V2500-A1/A5 SERIES PROPULSION SYSTEM SERVICE BULLETIN

This document transmits the Initial Issue of Service Bulletin V2500-ENG-73-0202.

ENGINE – FUEL AND CONTROL – P4.9 TUBE ASSEMBLIES, PRESSURE CONTROL AND BOX AND CABLE,
TC – REPLACE THE P4.9 TUBE ASSEMBLIES TO PREVENT FRACTURES AND REPOSITION THE EXHAUST
GAS TEMPERATURE (EGT) CABLE TO PREVENT CHAFING

LOCATION OF THE LEFT PRESSURE CONTROL TUBE ASSEMBLY
73-22-51
FIGURE 7

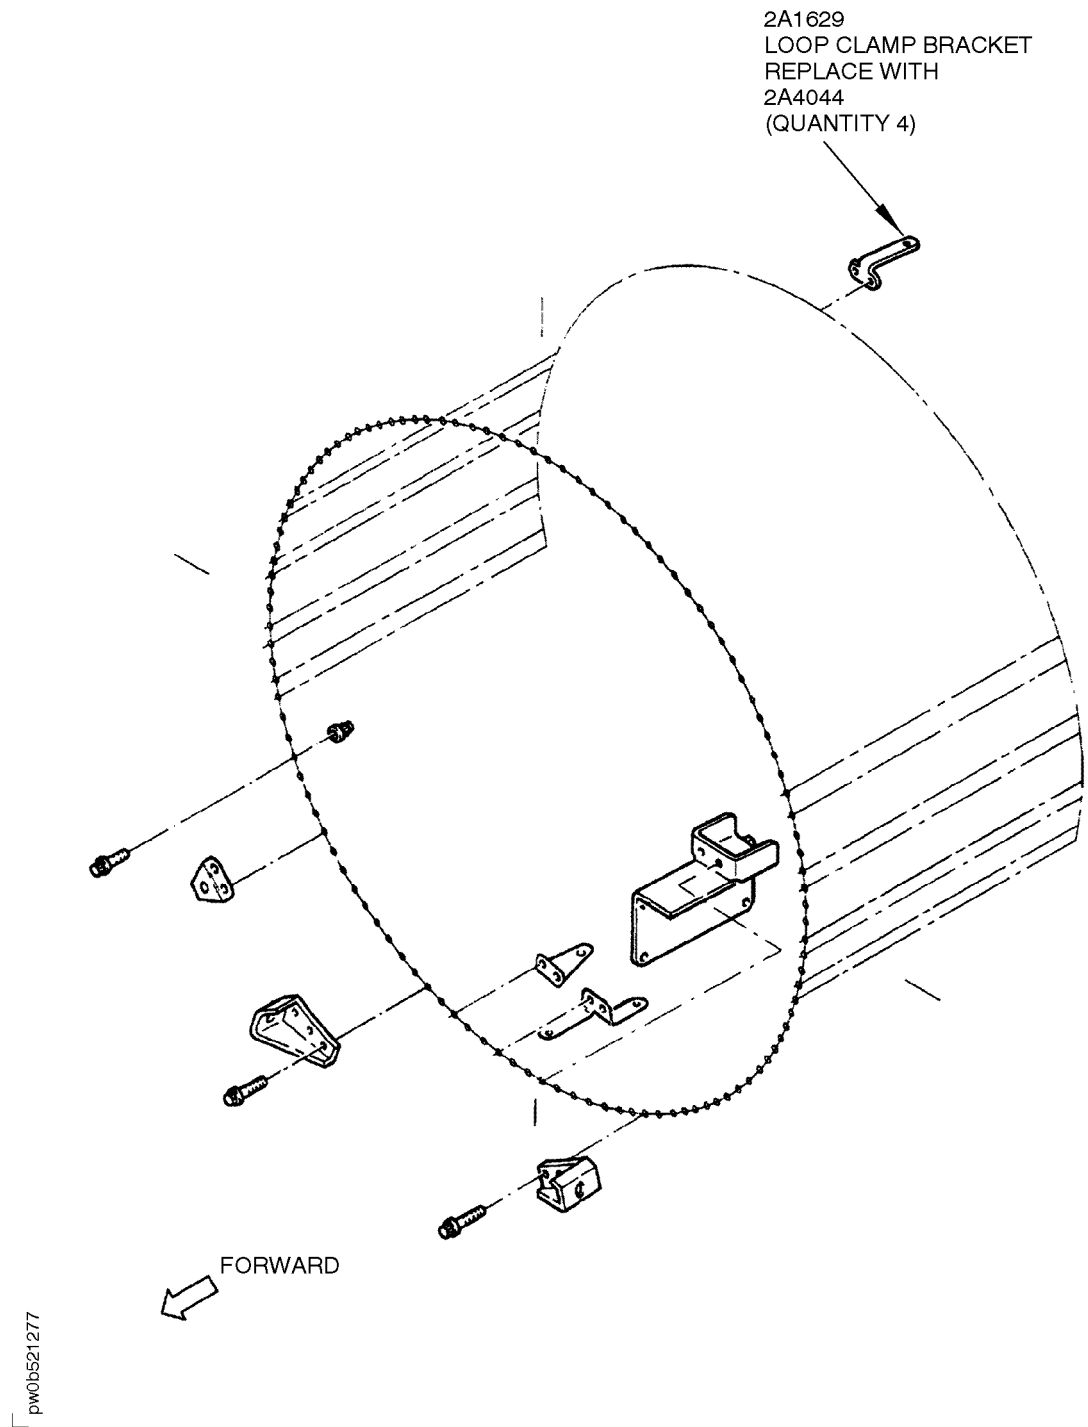
- (1) Do the following procedures on the left side of the turbine exhaust case group during engine assembly:
- (a) Replace Loop Clamp Bracket, P/N 2A3123 with P/N 2A4080. See Figure 6, Sheet 2 for the location of the bracket.
 - (b) Replace the Left Pressure Control Tube Assembly, P/N 2A3124-01 with P/N 2A4035-01. See Figure 7 for the location of the tube assembly.

LOCATION OF THE LOOP CLAMP BRACKETS
72-50-00
FIGURE 8

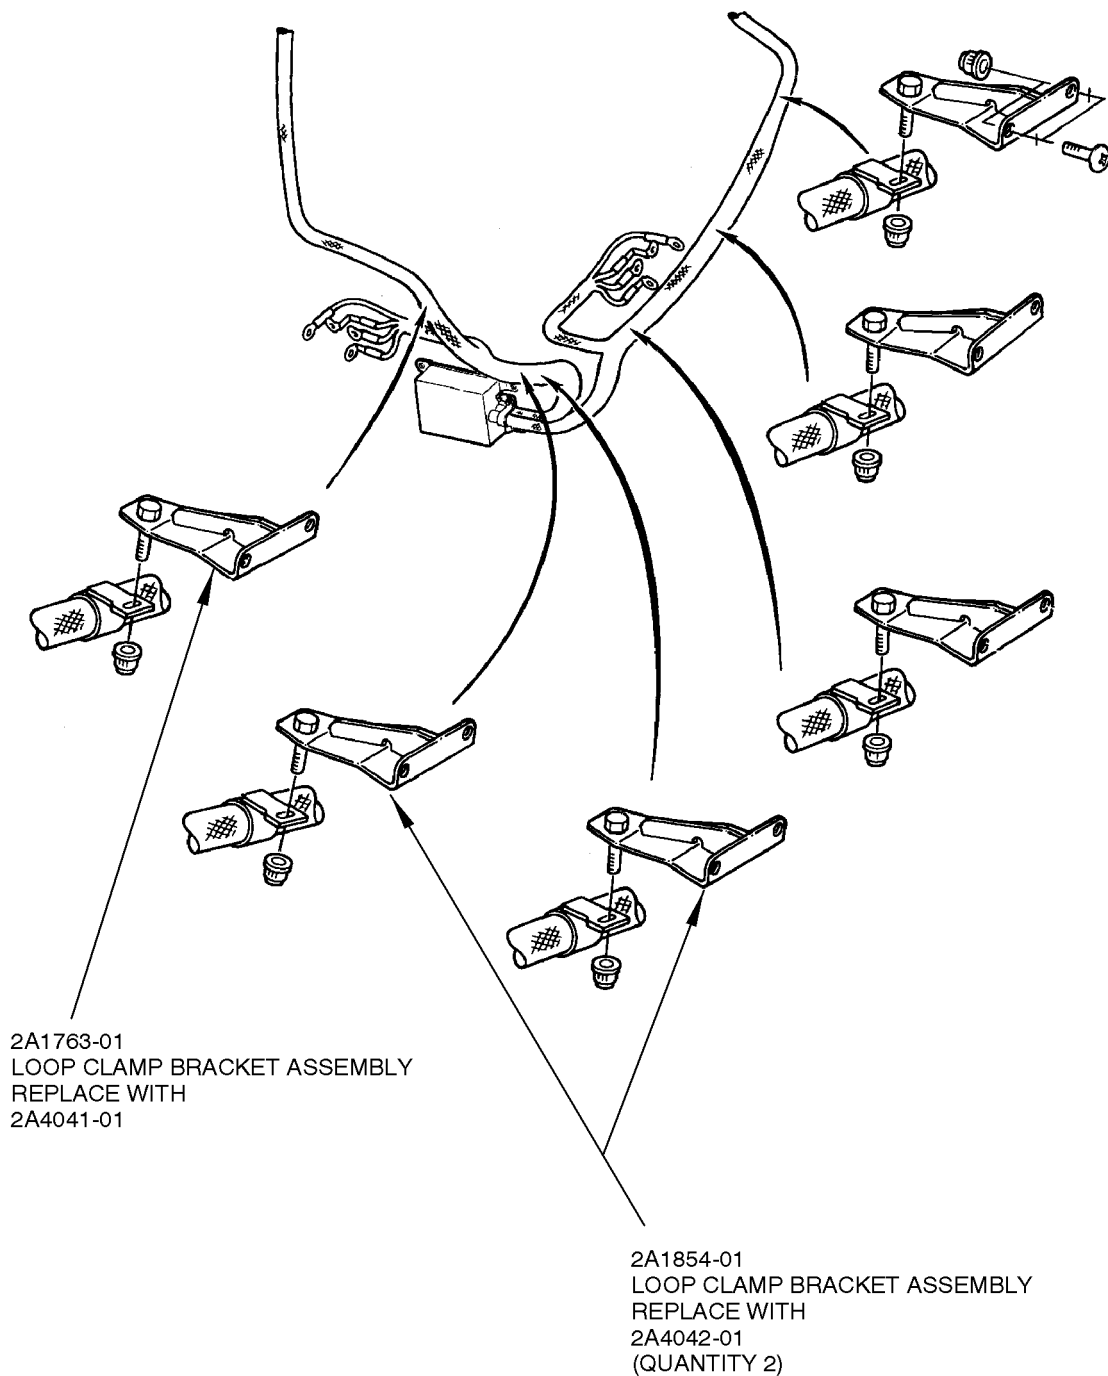
- (c) Replace four Loop Clamp Brackets, P/N 2A1629 with P/N 2A4044. See Figure 8 for the location of the brackets.
 - (d) Replace two Loop Clamp Bracket Assemblies, P/N 2A1854-01 with P/N 2A4042-01. See Figure 9 for the location of the brackets.

LOCATION OF THE LOOP CLAMP BRACKETS
77-21-43
FIGURE 9

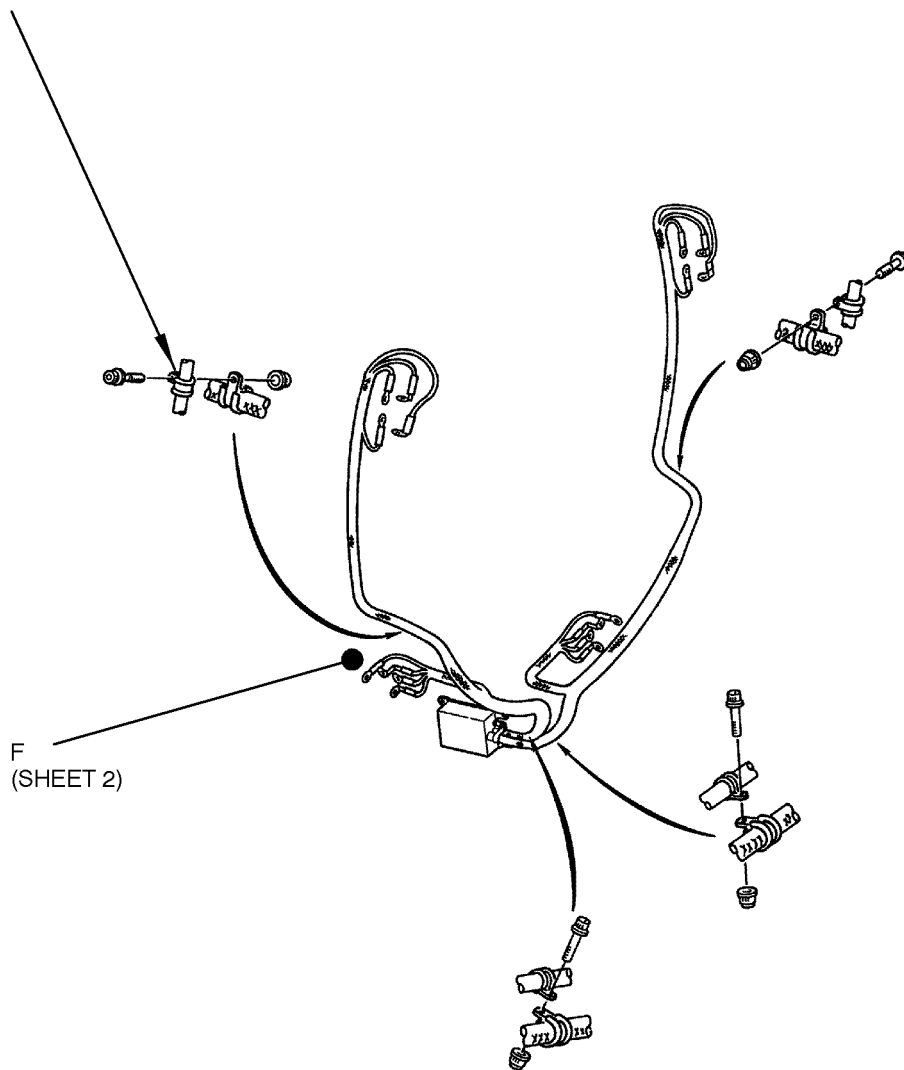
- (e) Replace Loop Clamp bracket Assembly, P/N 2A1763-01 with P/N 2A4041-01. See Figure 9 for the location of the bracket.
 - (f) Discard Clamp, P/N 277398 or Cushion Loop Clamp, P/N ST1428-02. See Figure 10, Sheet 1 for the location of the clamp. See Figure 10, Sheet 2 for EGT harness clamping and routing.

LOCATION OF THE CLAMP OR CUSHION LOOP CLAMP AND EGT HARNESS CLAMPING AND ROUTING
FIGURE 10, SHEET 2

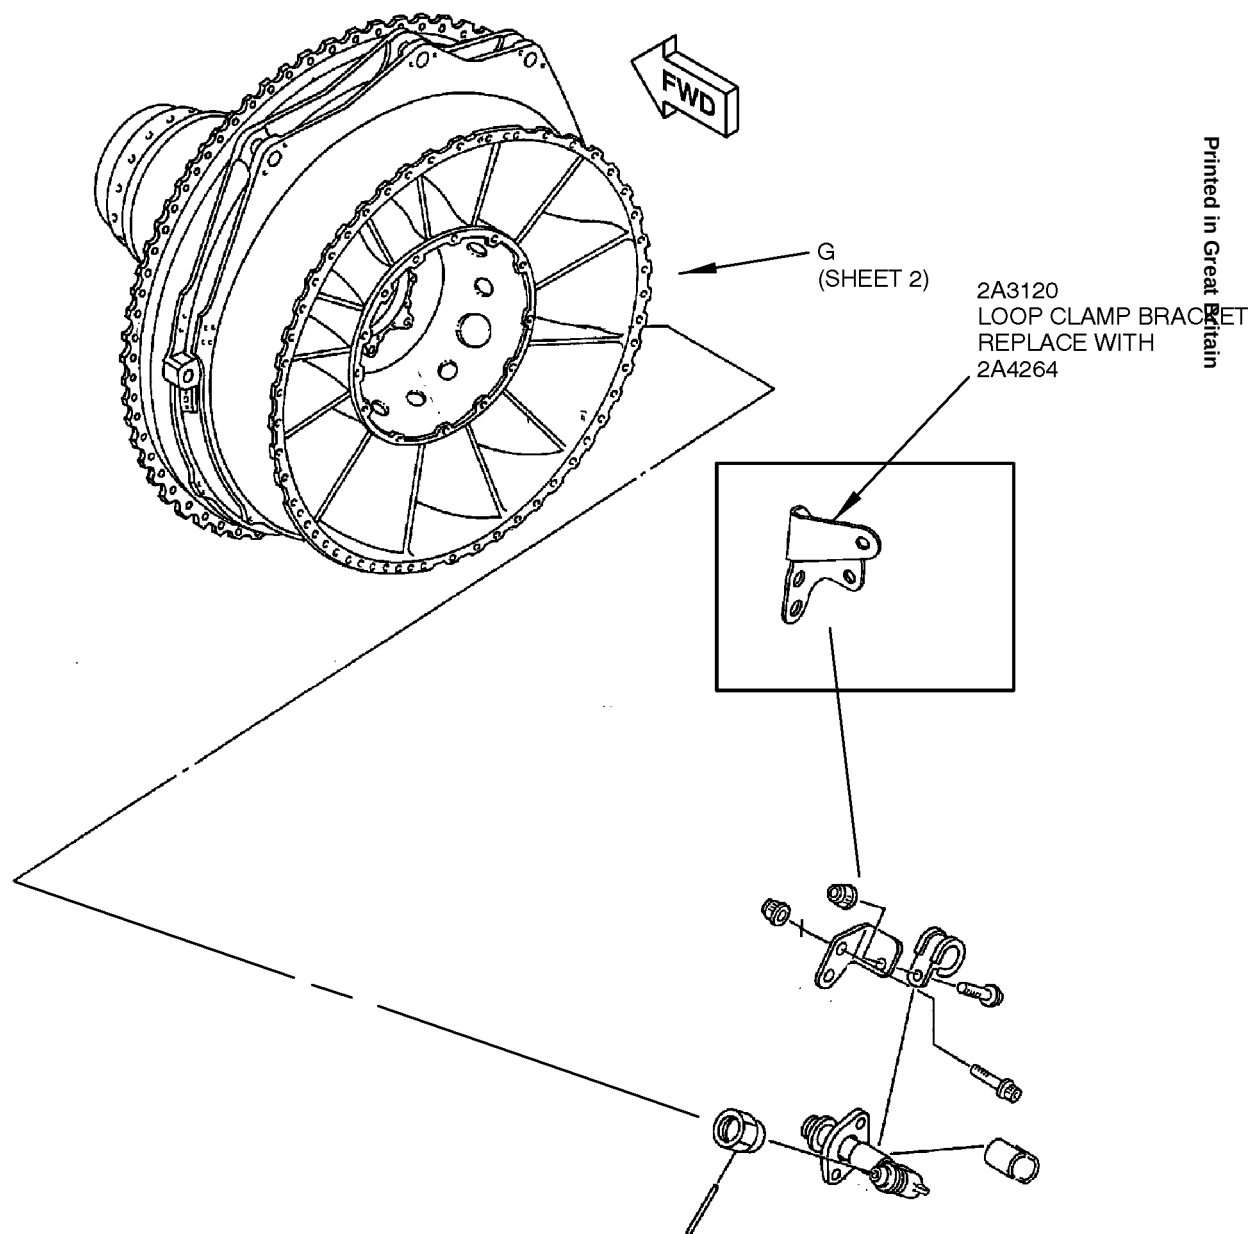
NOTE: This Service Bulletin introduces a new left pressure control tube assembly. The new tube assembly includes an integral clamp. The integral clamp performs the same function as the clamp removed by this step. See Figure 10, Sheet 2 for location of the integral clamp.

LOCATION OF THE LOOP CLAMP BRACKET
FIGURE 11, SHEET 2

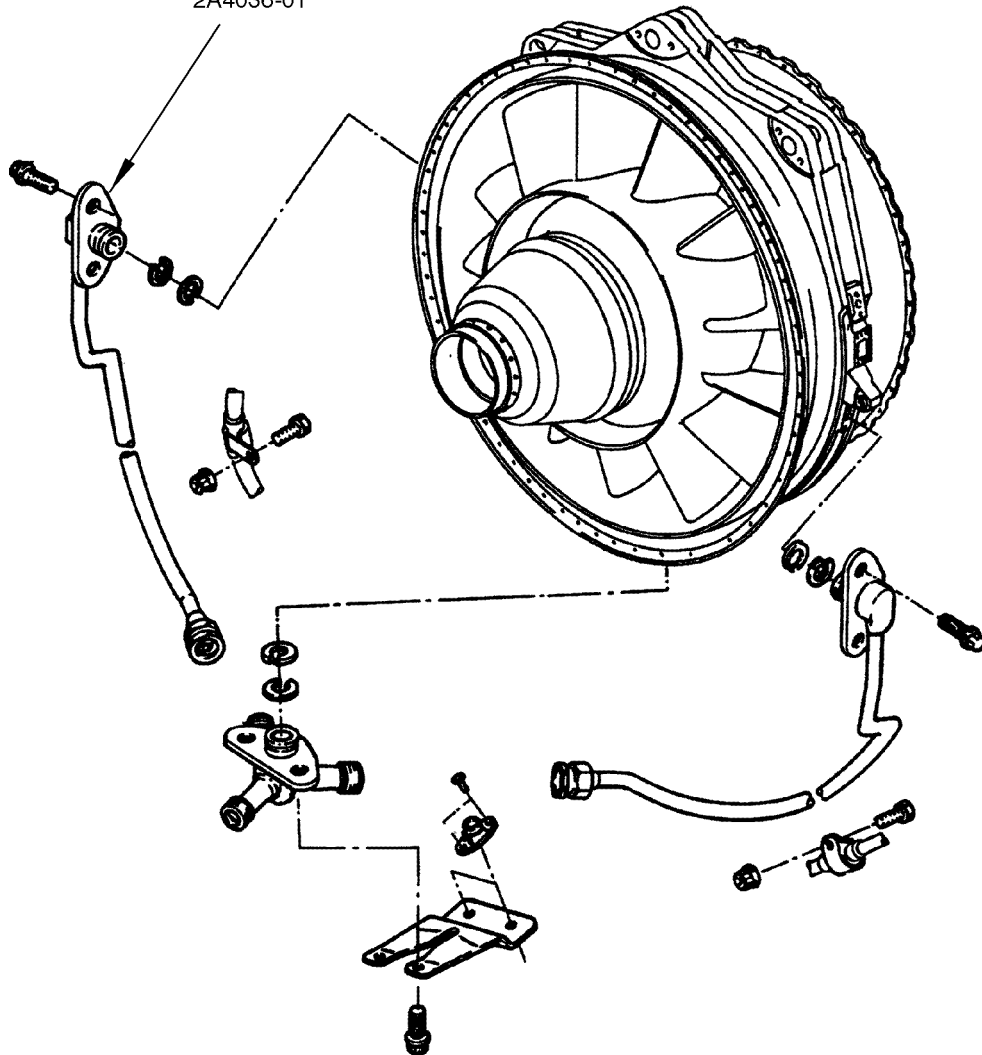
- (2) Do the following procedures on the right side of the turbine exhaust case group during engine assembly:
- (a) Replace Loop Clamp Bracket, P/N 2A3120 with P/N 2A4264. See Figure 11, Sheet 2 for the location of the bracket.
 - (b) Replace the Right Pressure Control Tube Assembly, P/N 2A3125-01 with P/N 2A4036-01. See Figure 12 for the location of the tube assembly.

LOCATION OF THE RIGHT PRESSURE CONTROL TUBE ASSEMBLY
73-22-51
FIGURE 12

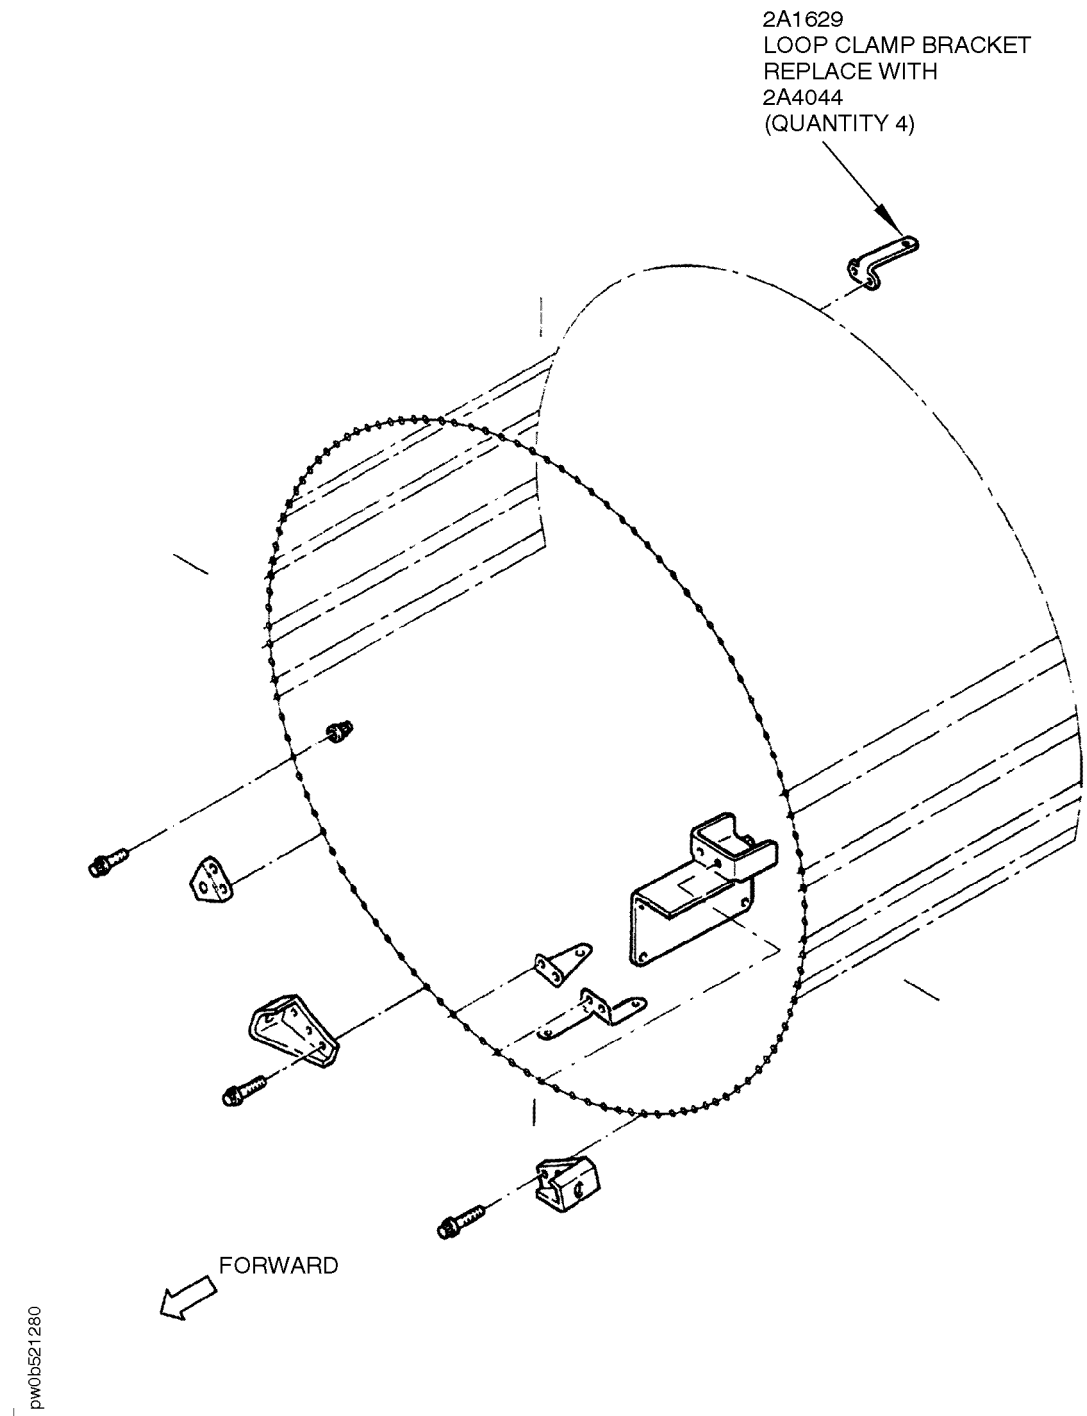
2A3125-01
RIGHT PRESSURE CONTROL
TUBE ASSEMBLY
REPLACE WITH
2A4036-01

LOCATION OF THE CLAMP OR CUSHION LOOP CLAMP AND EGT HARNESS CLAMPING AND ROUTING
FIGURE 15, SHEET 2

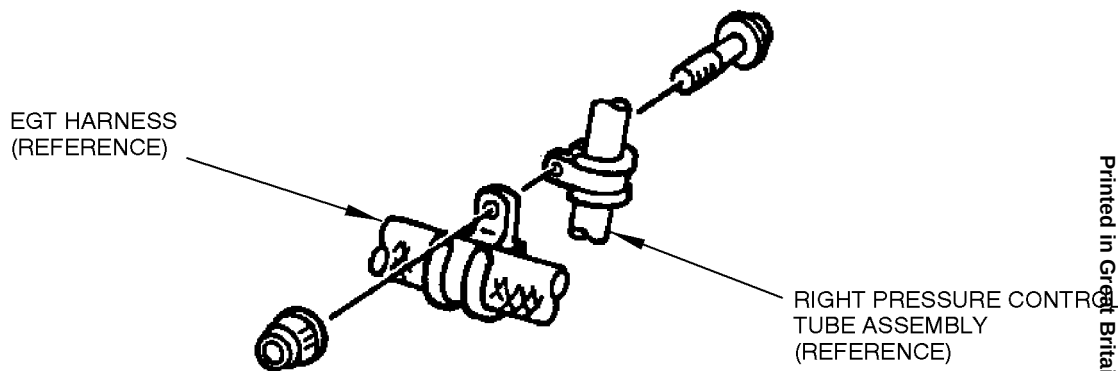
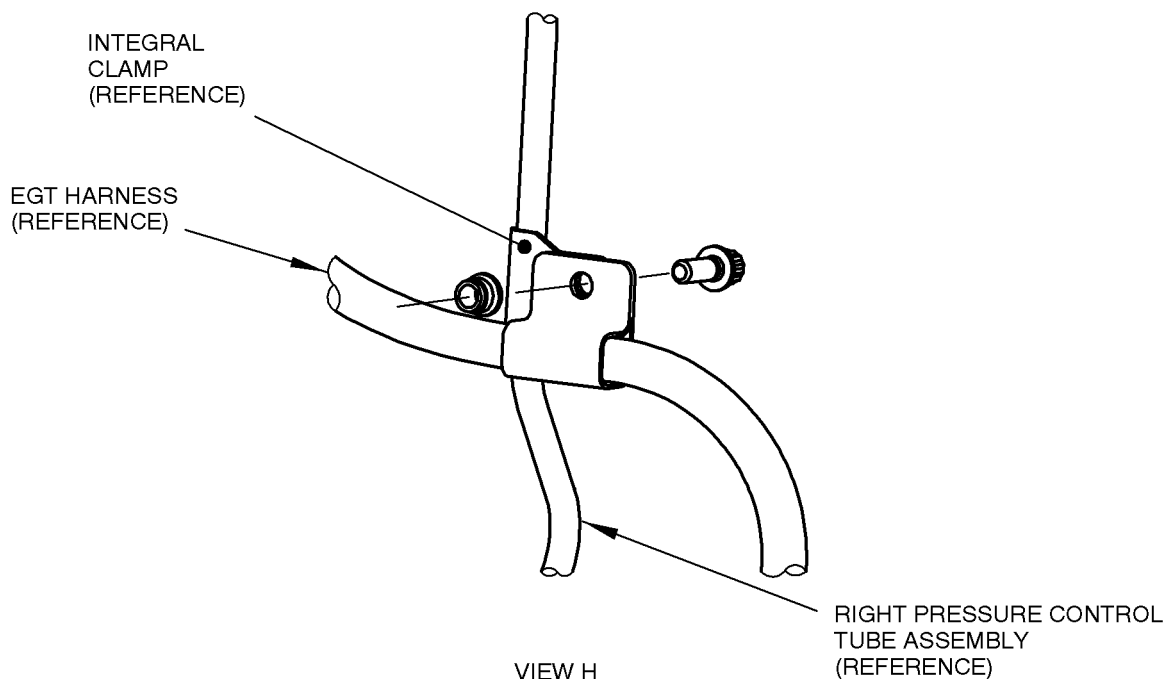
NOTE: This Service Bulletin introduces a new right pressure control tube assembly. The new tube assembly includes an integral clamp. The integral clamp performs the same function as the clamp removed by this step. See Figure 15, Sheet 2 for location of the integral clamp.

LOCATION OF THE LOOP CLAMP BRACKET
73-22-51
FIGURE 16

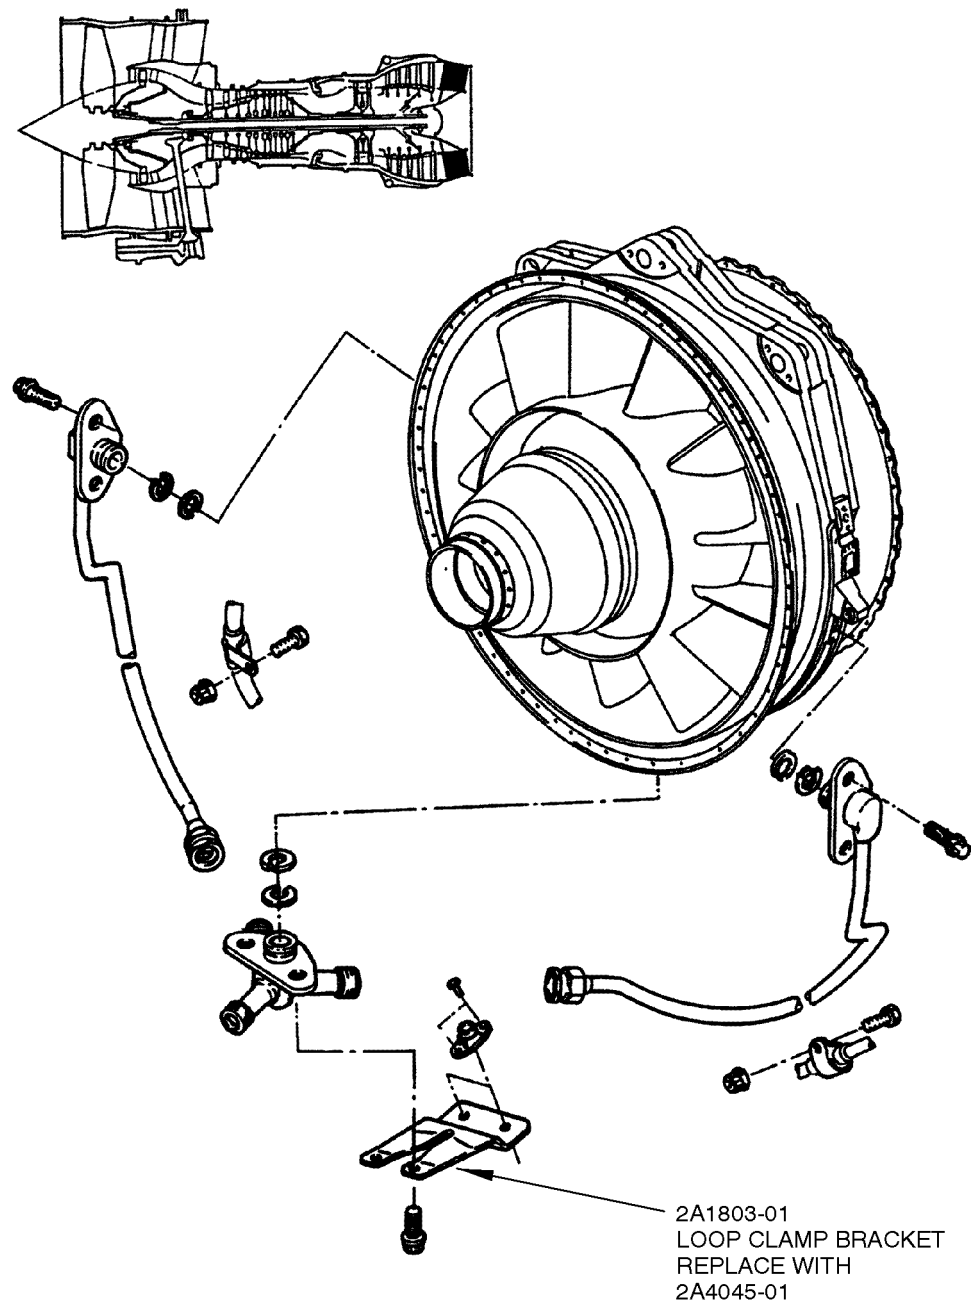
(a) Replace Loop Clamp Bracket, P/N 2A1803-01 with P/N 2A4045-01. See Figure 16 for the location of the bracket.
